SECTION 4.55 PROPOSED SHOP TOP HOUSING DEVELOPMENT

Project PROPOSED SHOP TOP HOUSING DEVELOPMENT

Project Address 9 Sherwood Road, Merrylands

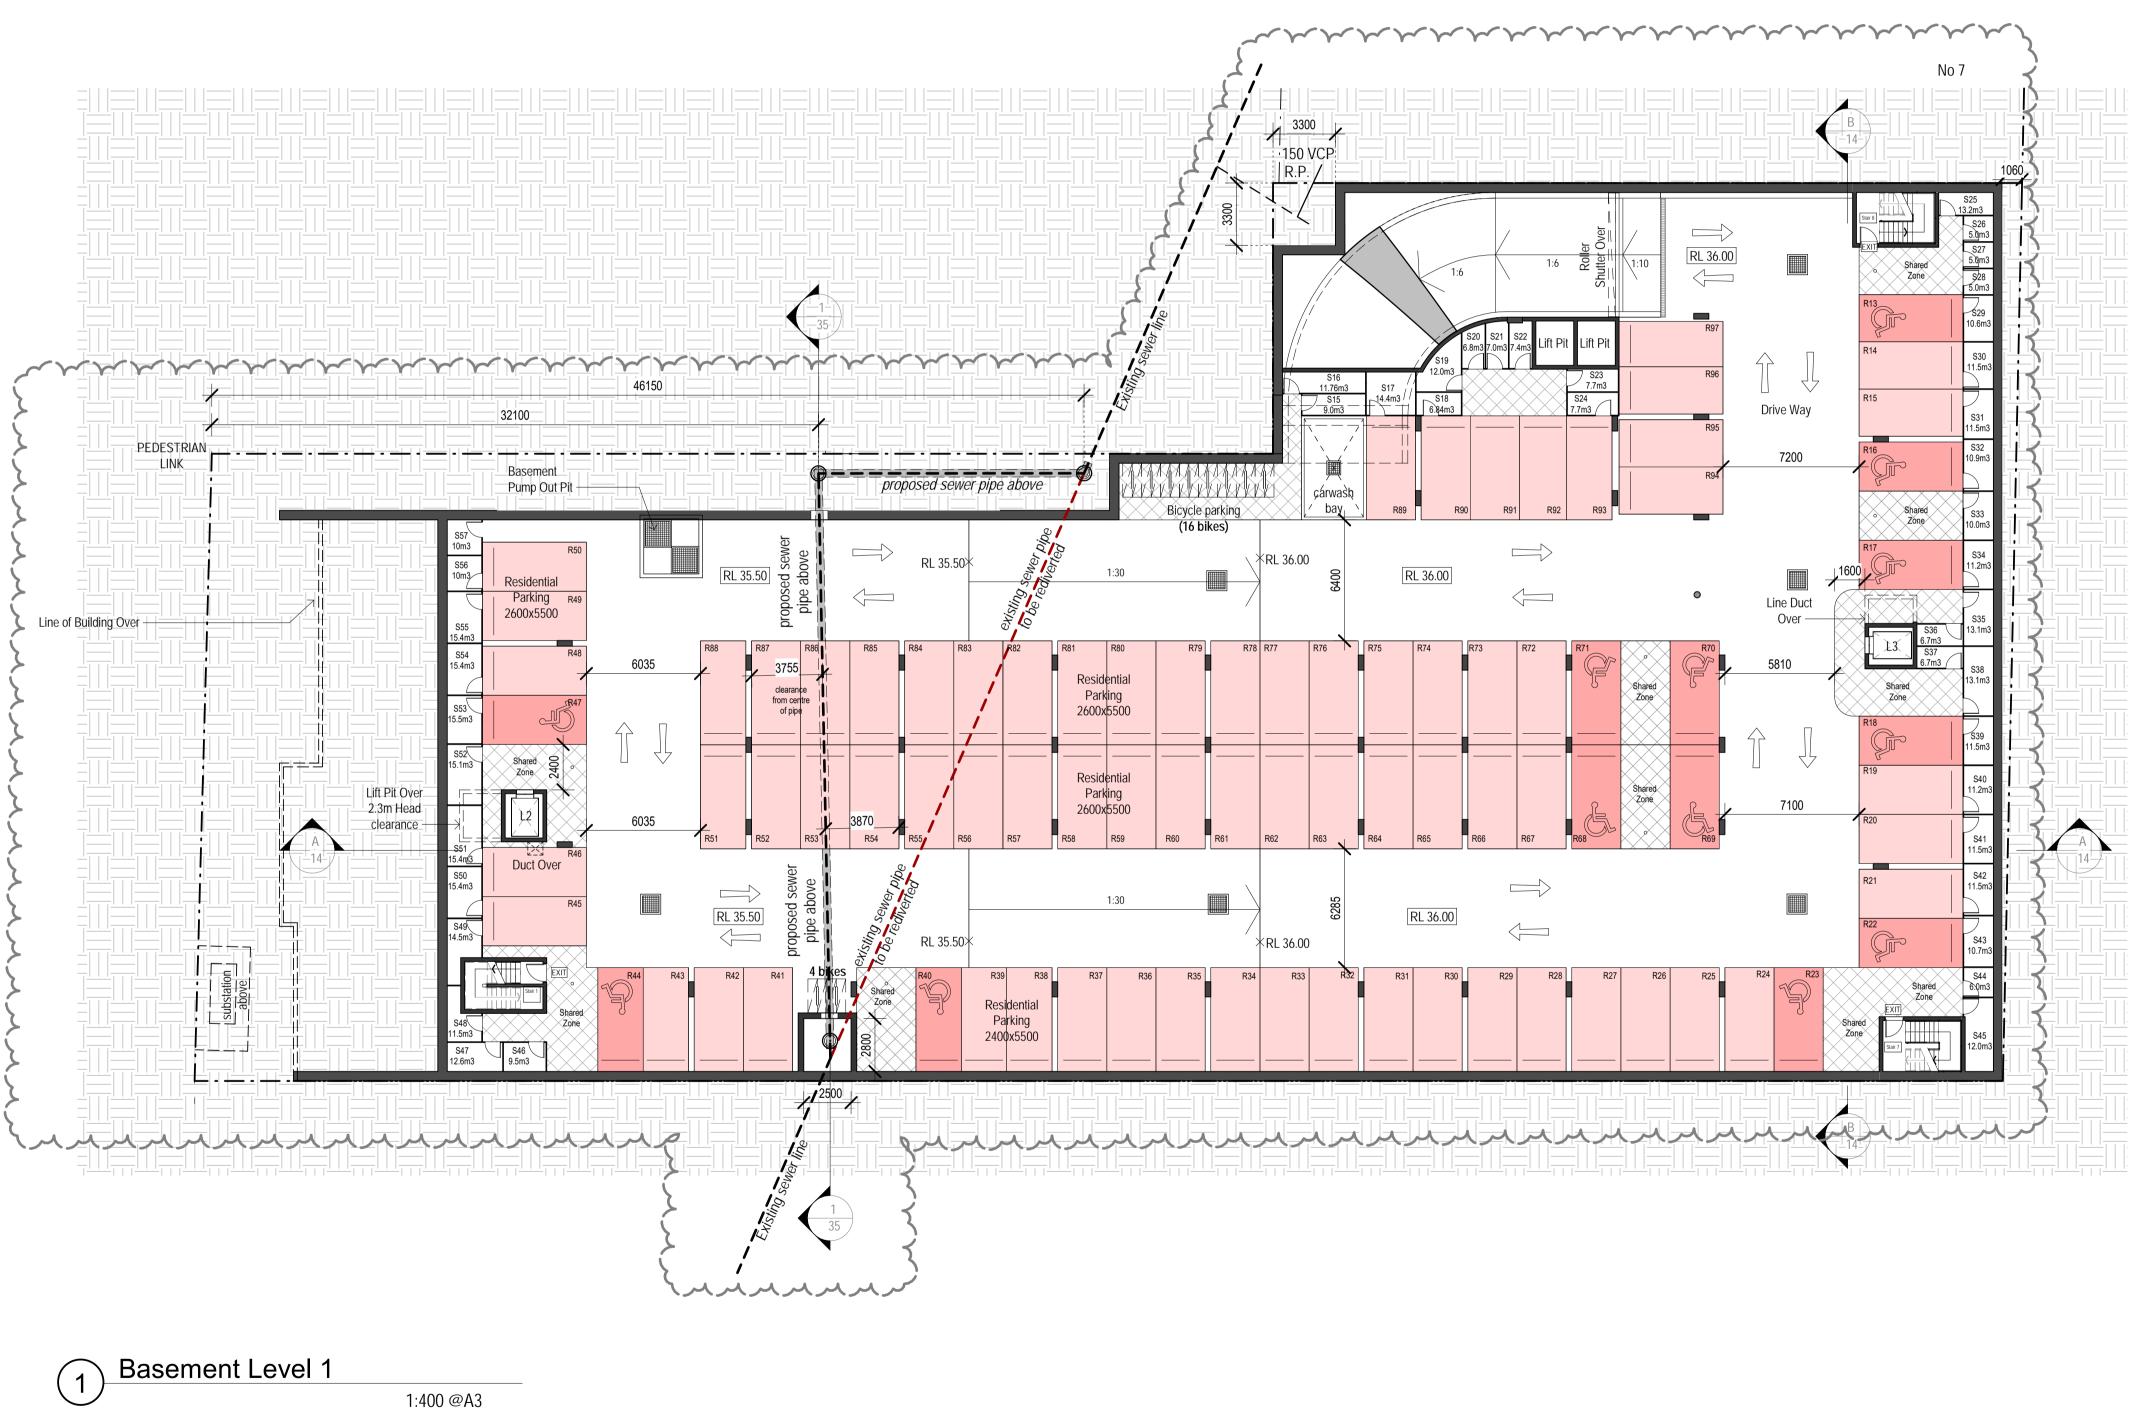
-Parking Allocation Amended

1 Level 1 1:400 @A3

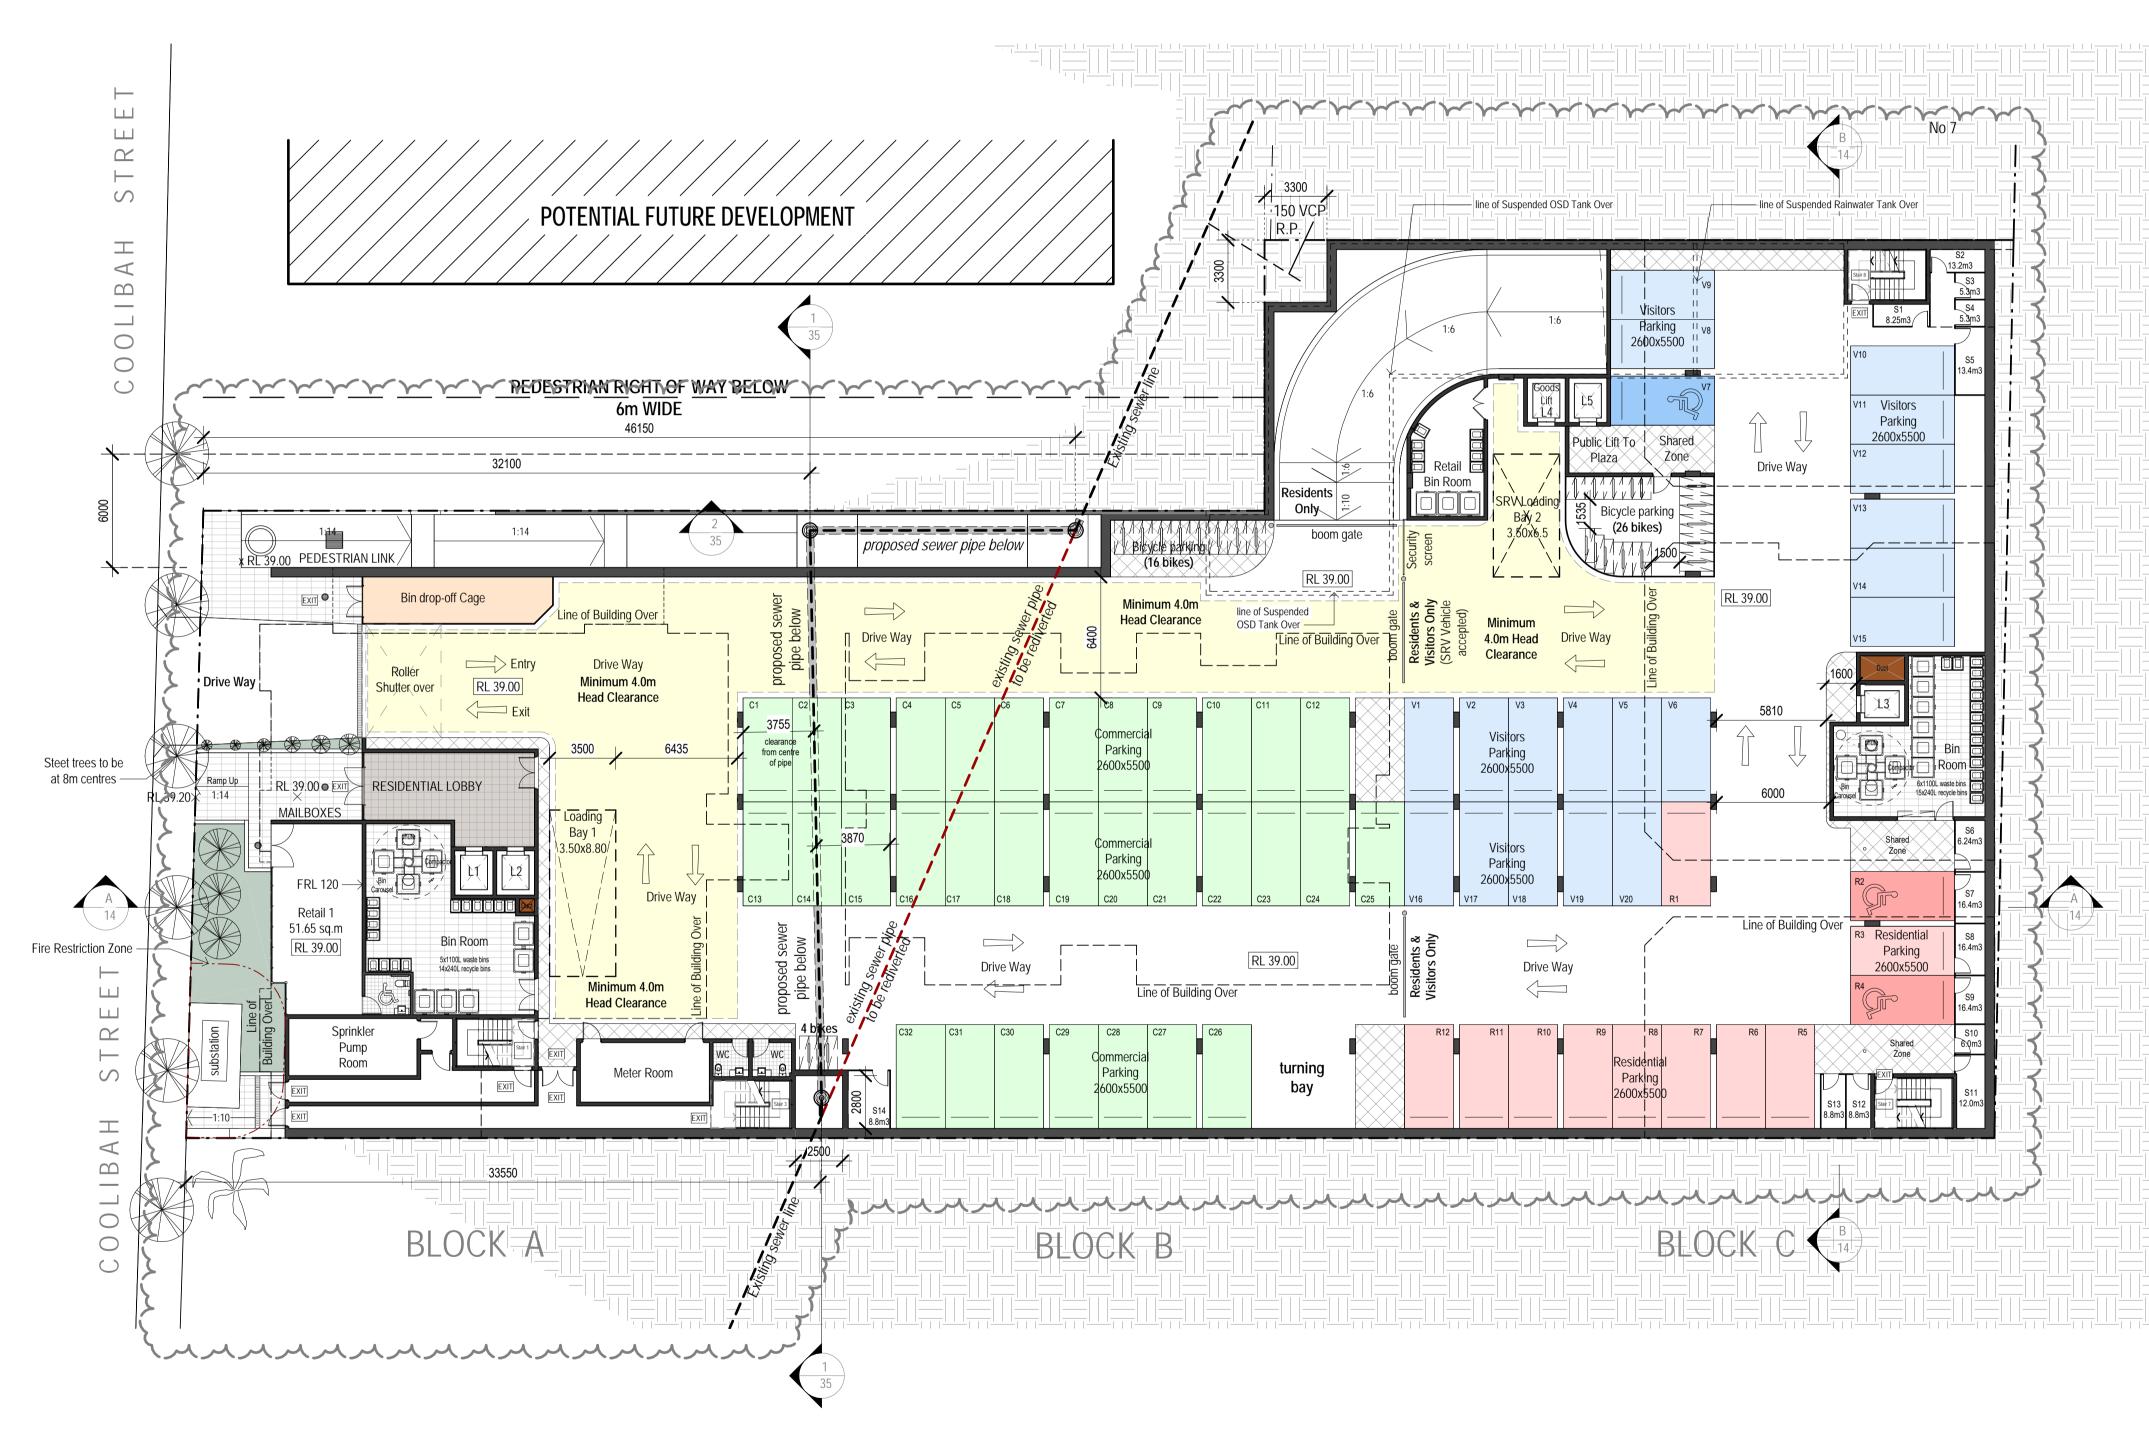
- Increase size of bin carousel as per elephants foot details.
 Adjust size of retail unit 1 to allow for bigger bin carousel.
 Introduced bin drop off point / cage.
 Parking Allocation Amended
- -Parking Allocation Amended
- -Loading Bays relocated

Level 4

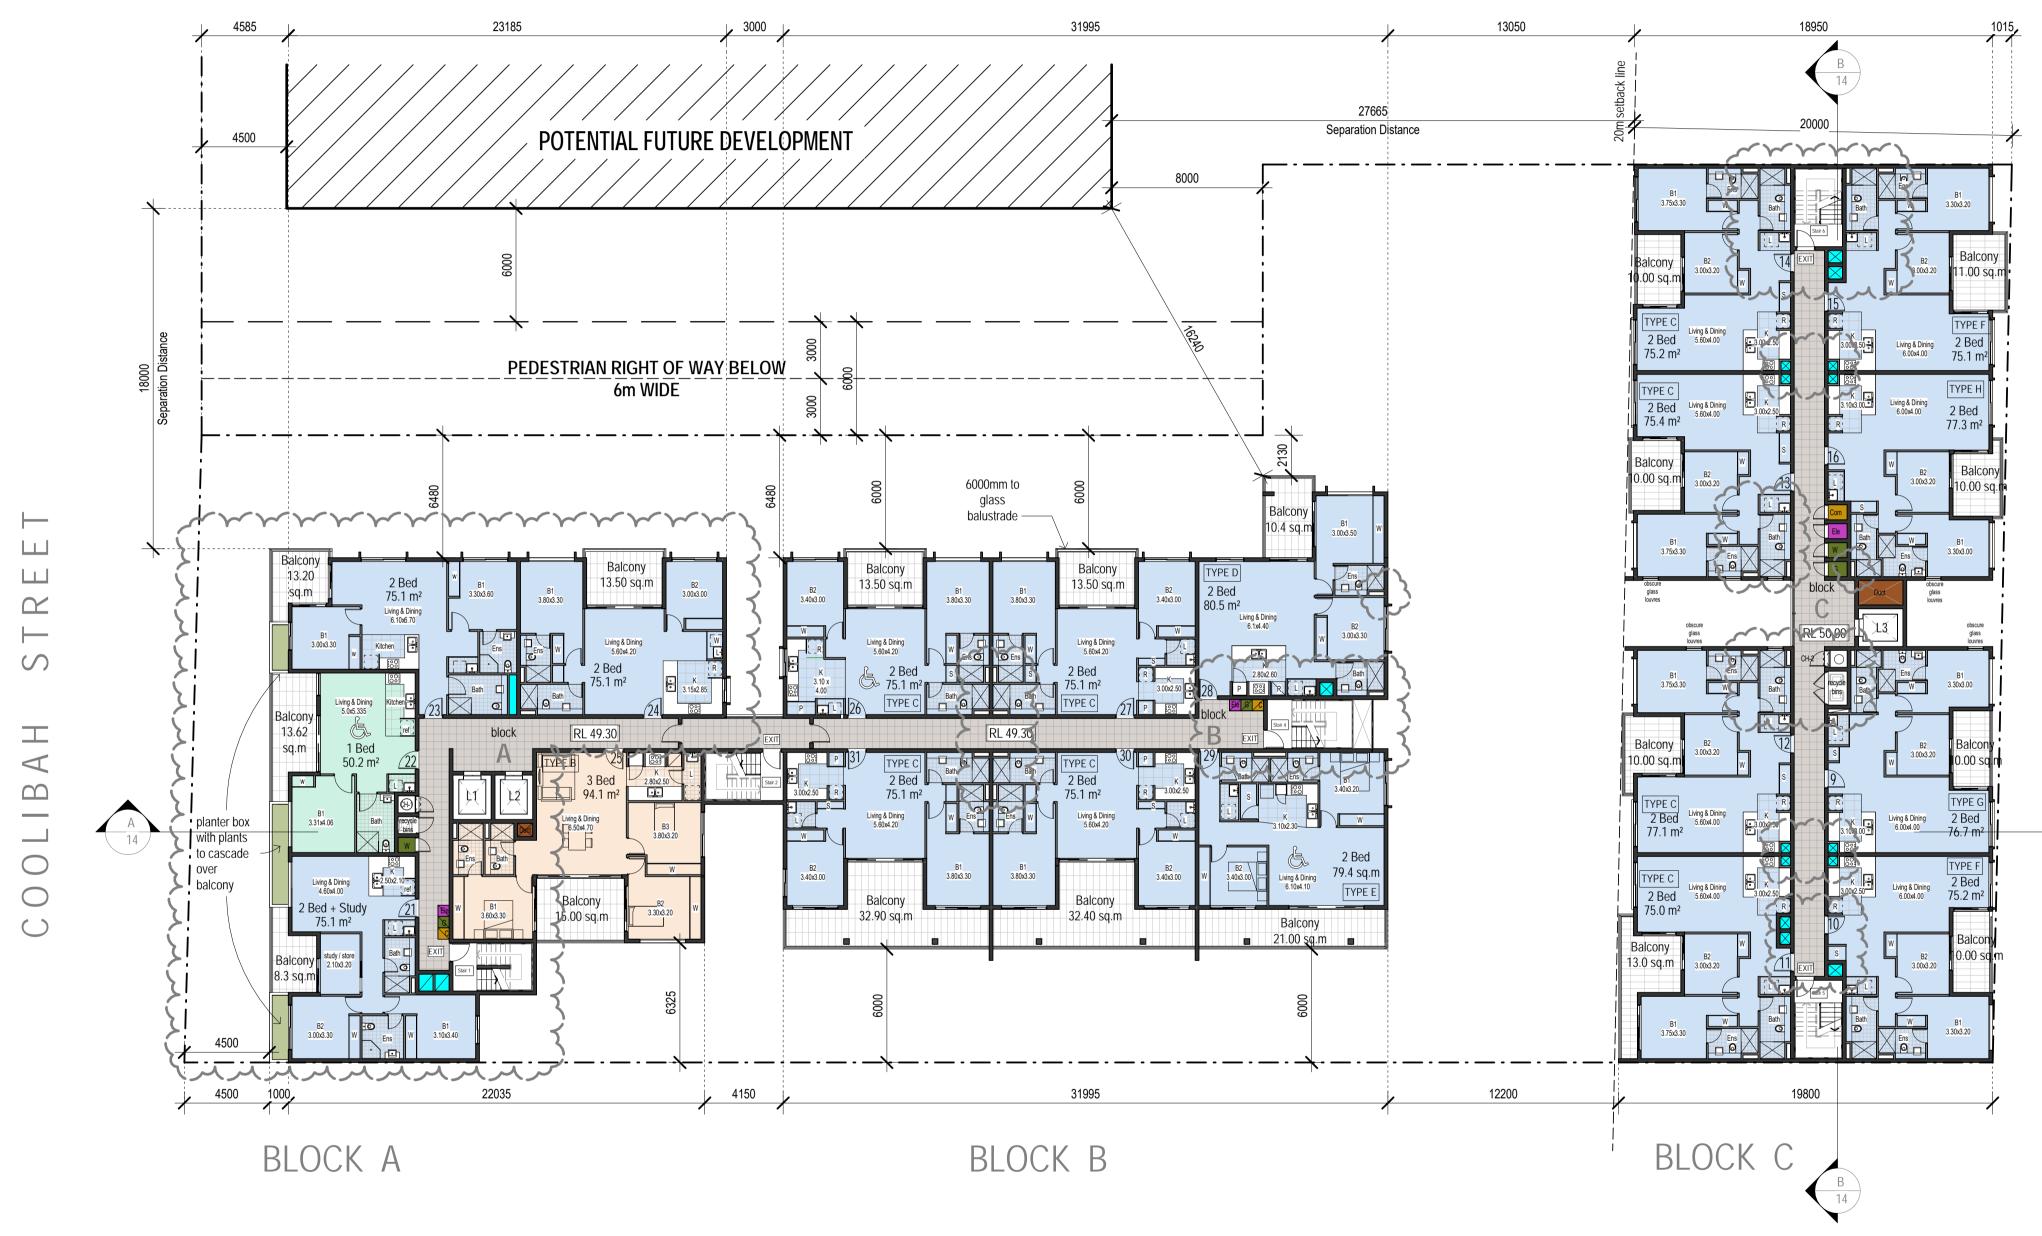
Move Building A+B back to be in 6.0m setbackCorner units in Block A+B amended.

Privacy screen removed from bedrooms and balconies.

Glass louvre windows added for improvements to cross ventilation to all Buildings.

- Windows added for improvements to cross ventilation in Block C.

Blade walls reduced to improve Solar access.6.0m setbacks shown on all plans.

-Service Ducts Added - Floor Levels Amended
